ANDERSON & ASSOCIATES, INC. Professional Design Services www.andassoc.com 100 Ardmore St. Blacksburg, Va. 24060 540-552-5592	DATE : 07 JUN 13 DESIGNED: CSF DRAWN : SEC CHECKED : MGG QA / QC : CSF	REV. # COMMENTS DATE	**FRANKLIN COUNTY / WESTERN VIRGINIA WATER AUTHORITY** BURNT CHIMNEY WATER EXTENSION FRANKLIN COUNTY, VIRGINIA	**Line A - Sta 340+00 to 355+00** **PLAN AND PROFILE**

DOCUMENT NO. 30337 – 002
SHEET 30 OF 44

LINE A [STA. 340+00 to STA. 355+00]

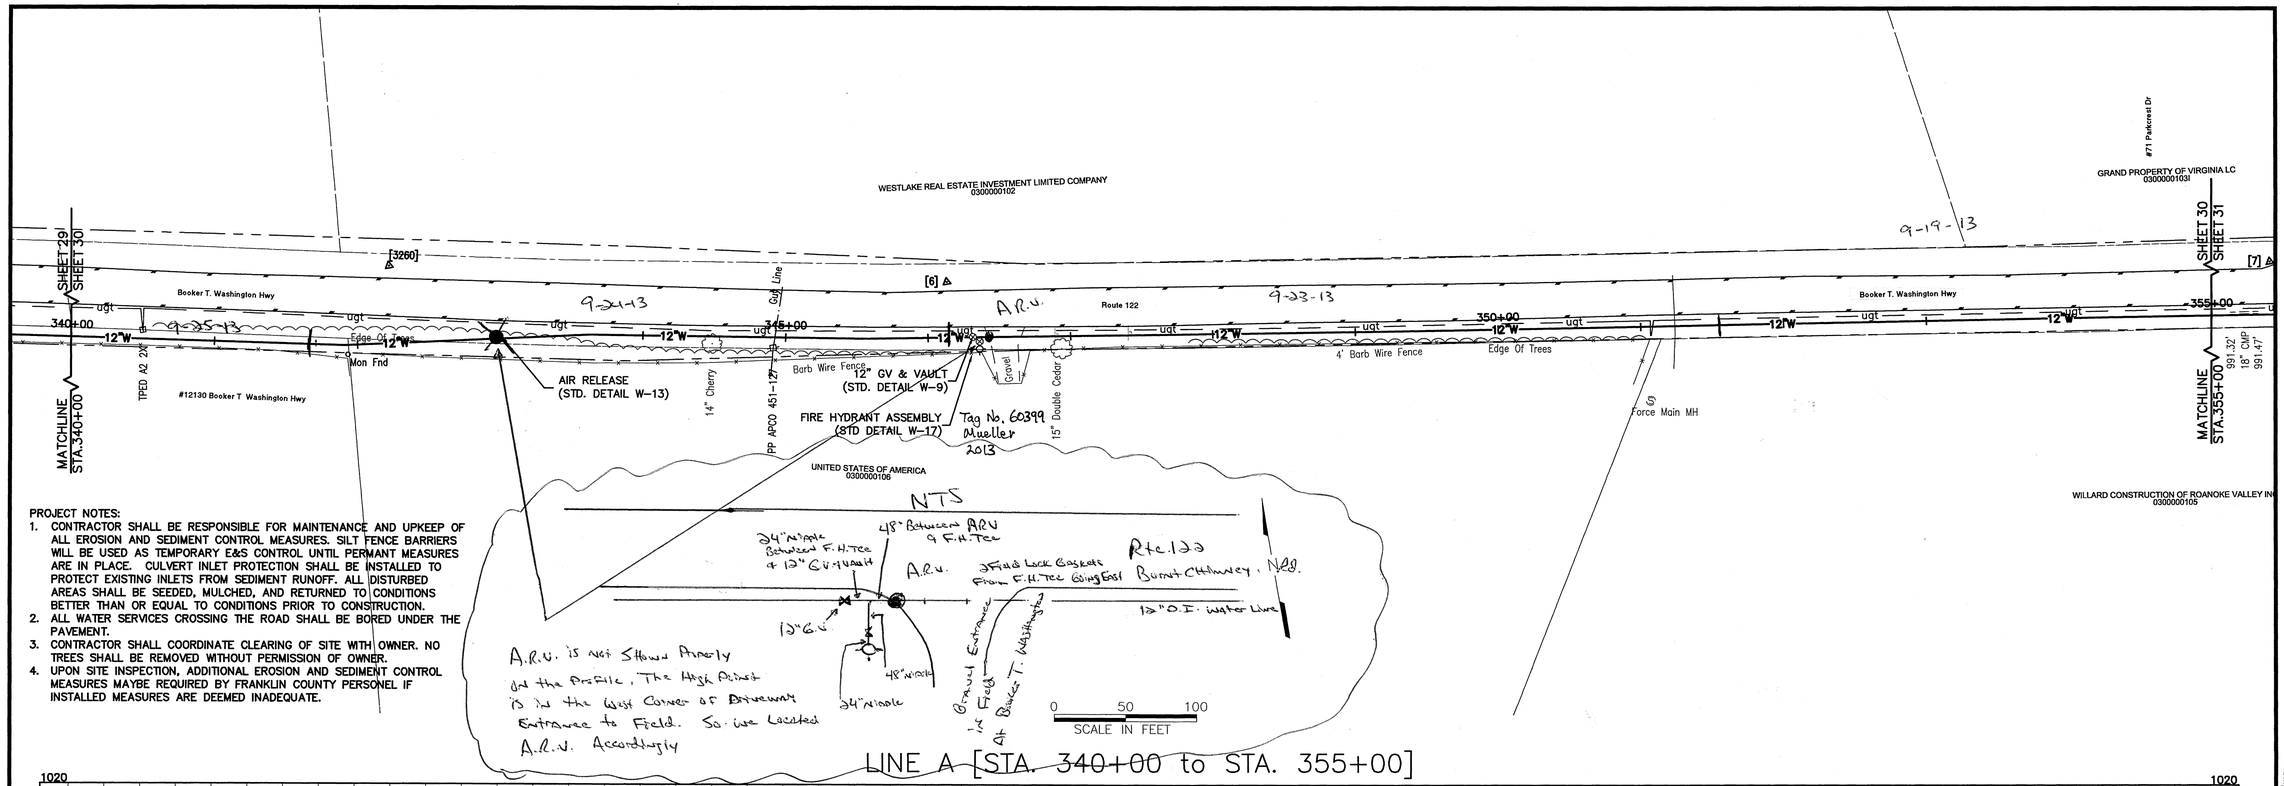
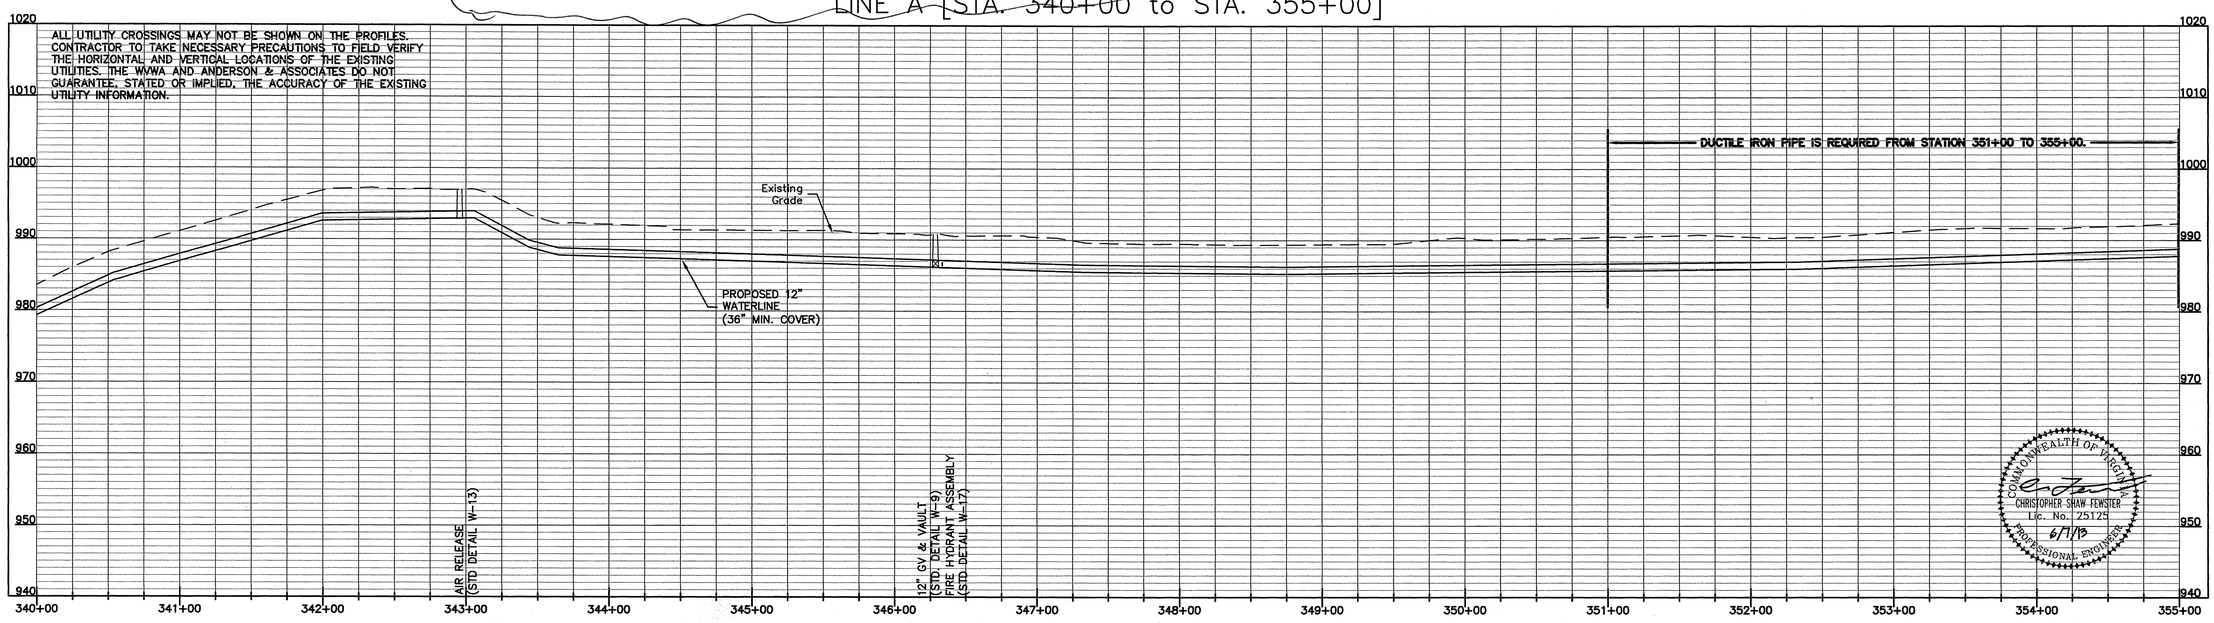
A.R.V. is not shown properly on the profile. The high point is in the West Corner of Driveway Entrance to Field. So we located A.R.V. Accordingly
